**Monitoring Report  
Year 3  
FINAL  
Little Buffalo Creek Stream Mitigation Project**

*NCDEQ-DMS Project Number: 94147  
Contract Number: 2029  
USACE Permit Action ID: 2014-00386  
DWR Permit: 14-0129  
Cabarrus County*

Subject: DRAFT Monitoring Year 3 report for the  
Little Buffalo Creek Stream Mitigation Project  
Yadkin River Basin – CU# 03040105– Cabarrus County  
DMS Project ID No. 94147  
Contract # 002029

Figure A1 – Project Components Map

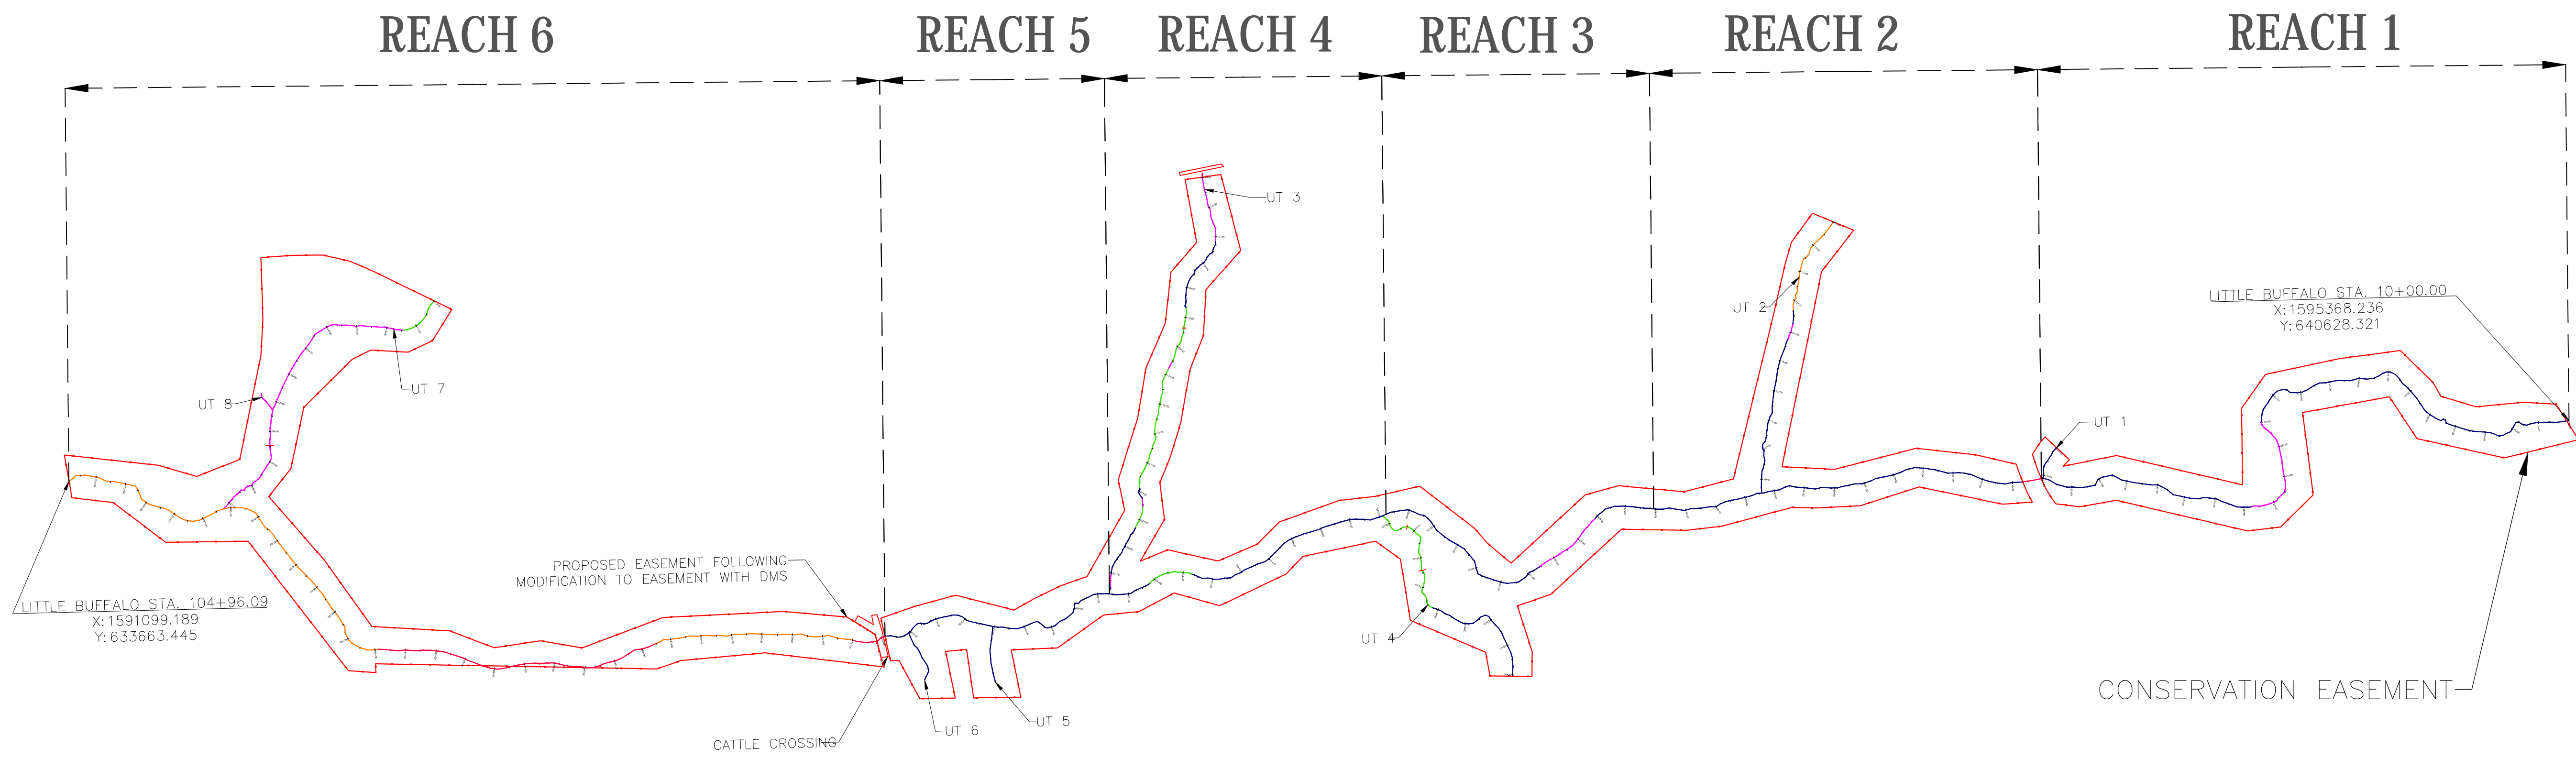
**Figure A1: Table 1 Stream Mitigation By Reach Figure:** Please amend or replace the figure. This figure is typically called the “Project Components Map”. The project streams should be shown and colored as “Stream Restoration”; “Stream Enhancement (Level I)”; “Stream Enhancement (Level II)”; “Stream Preservation” and “No Credit” with different colors to represent each approach on the map and in the legend. Please be sure to include the conservation easement shape and crossing cutouts on the map. All project reaches and UT #s should be labeled on the map but stationing is not required as it is included in Table 1. GIS shapefiles should be updated accordingly and included in the required MY3 support files.

- **Figure A1:** Table 1 Stream Mitigation by Reach Figure: Please amend or replace the figure. This figure is typically called the “Project Components Map”. The project streams should be shown and colored as “Stream Restoration”; “Stream Enhancement (Level I)”; “Stream Enhancement (Level II)”; “Stream Preservation” and “No Credit” with different colors to represent each approach on the map and in the legend. Please be sure to include the conservation easement shape and crossing cutouts on the map. All project reaches and UT #s should be labeled on the map but stationing is not required as it is included in Table 1. GIS shapefiles should be updated accordingly and included in the required MY3 support files.
  - *This figure has been amended as described.*

**Little Buffalo Creek Mainstem-Reach 1**  
 Longitudinal Profile, As-built Stationing 22+00 to 25+77.37

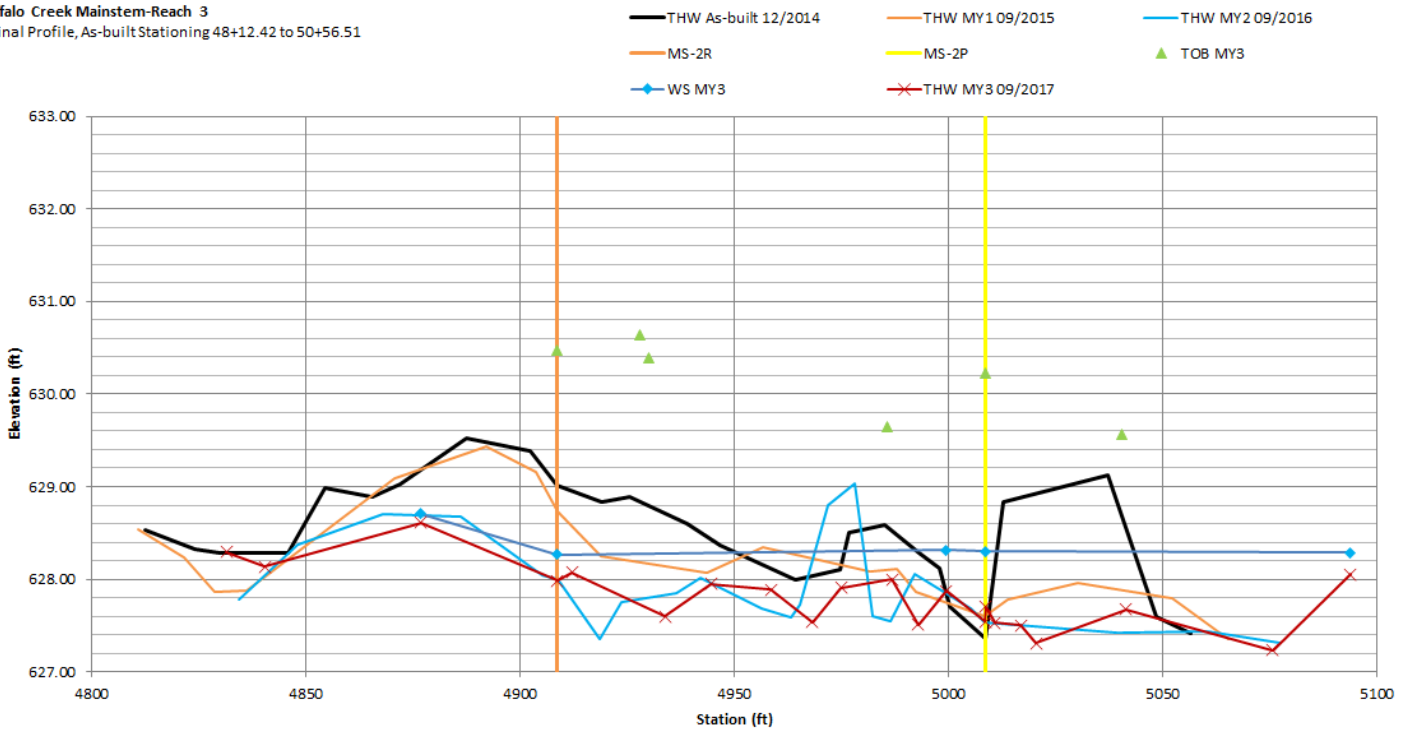
**Longitudinal Profiles:** The Mainstem Reach 1 Longitudinal Profile water surface data needs to be evaluated and corrected. Trendlines should not be used on water surface plots for any of these profiles, please correct with a simple line connecting the points.

- **Longitudinal Profiles:** The Mainstem Reach 1 Longitudinal Profile water surface data needs to be evaluated and corrected. Trendlines should not be used on water surface plots for any of these profiles, please correct with a simple line connecting the points.
  - *The water surface data was re-evaluated as requested. Note, the beaver dam located within the restoration reach, in tandem with the rain event occurring during the survey of this profile, was resulting in a backwater effect upstream of the dam. Trendlines have been removed from the longitudinal profiles.*
